Independent Verification Memo WO-02: HVAC Control Package Selection, Round 2

Verification chart: energy per candidate on the shared HVAC duty (kWh); bars drawn to true values 50/33/20/9 with gaps 17/13/11 kWh and quality-defect annotations; P4 sits at the five-defect ceiling.

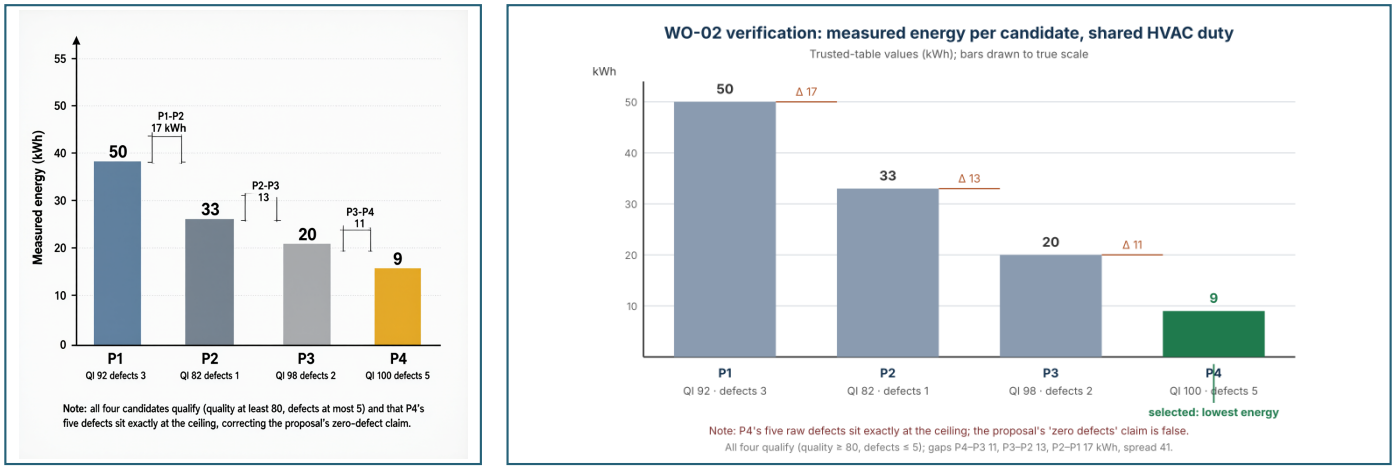
Recomputation against the trusted table confirms all four candidates qualify: quality indices 82-100 exceed the floor of 80, and raw defect counts 1-5 stay at or under the ceiling of 5 — P4 sits exactly at that ceiling. Measured energy on the shared HVAC duty basis ranks P4 9 kWh, P3 20, P2 33, P1 50; the minimum is unique, so the ID tie-break is idle and the written policy selects P4. The proposal's qualification screen, ranking and gaps are arithmetically correct, but two defect statements are false: it claims P4 has zero defects and counts of 0-3, contradicting the table's five. This error does not change the ranking; the P4 recommendation stands.
